ERNEST ESTATES SUBDIVISION

APPLICATION NUMBER 16 DATE January 16, 2014

REQUEST Subdivision

DETAIL SITE PLAN

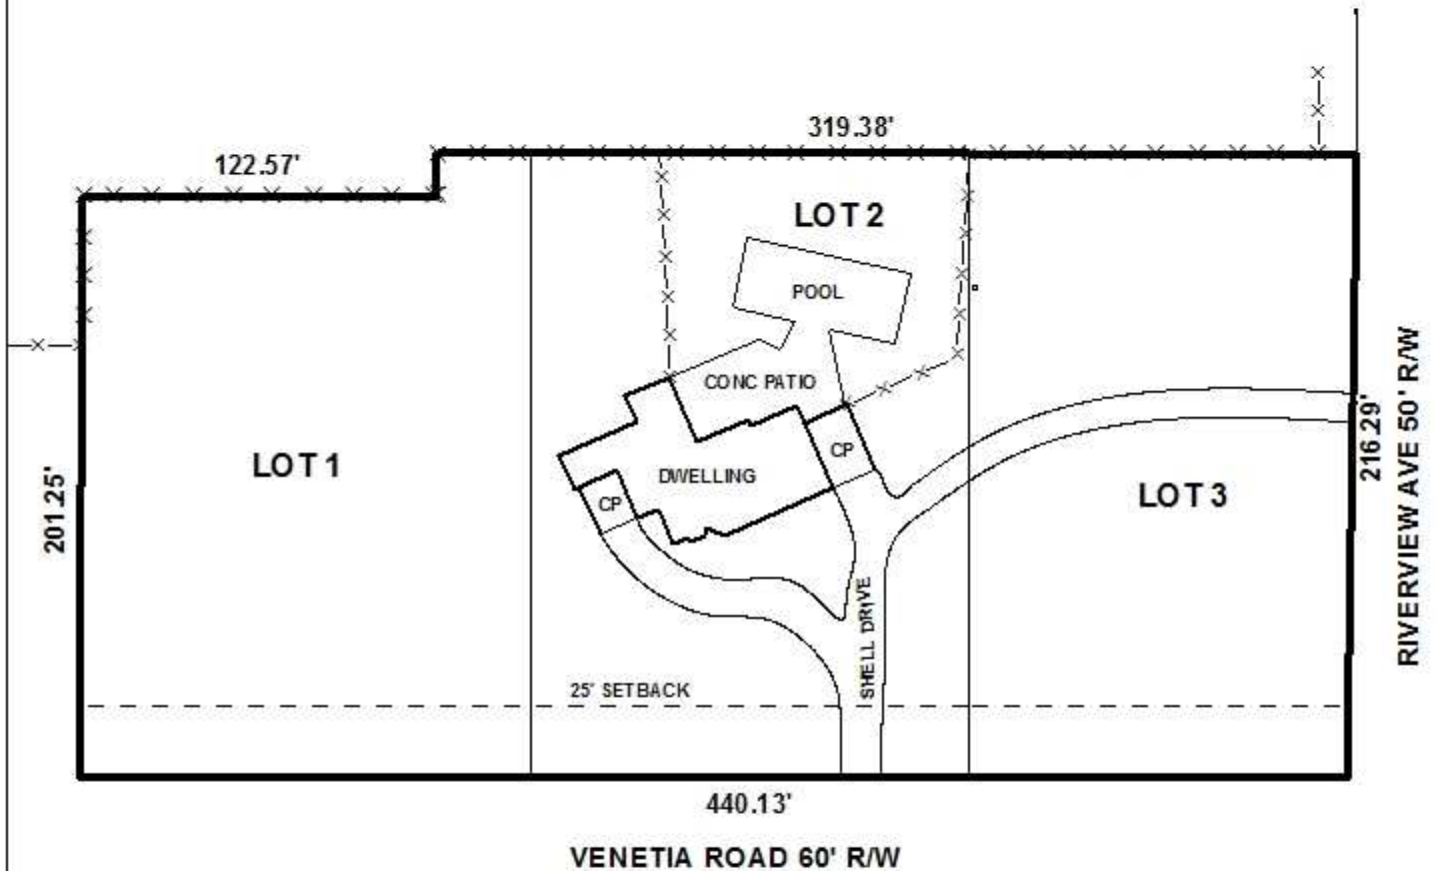
The preliminary plat indicates the 25' minimum building setback line along Venetia Road only. Therefore, the plat should be revised to illustrate a 25' minimum building setback line along both Venetia Road and Riverview Avenue. The plat should also be revised to comply with Section V.D.6. of the Subdivision Regulations to dedicate a radius curve at the intersection of Venetia Road and Riverview Avenue, to be coordinated with City Engineering and Traffic Engineering..

- 1) placement of a note on the Final Plat stating that each lot is limited to one curb cut, with the size, location and design of all curb cuts to be approved by City of Mobile Traffic Engineering and conform to AASHTO standards;

- 2) revision of the plat to indicate the 25' minimum building setback line along both Venetia Road and Riverview Avenue;
- 3) dedication of a radius curve, compliant with Section V.D.6. of the Subdivision Regulations, at the intersection of Venetia Road and Riverview Avenue, to be coordinated with City Engineering and Traffic Engineering;

- 4) retention of the labeling of each lot with its size in both square feet and acres, adjusted for any required dedication on Lot 3, or the furnishing of a table on the Final Plat providing the same information;
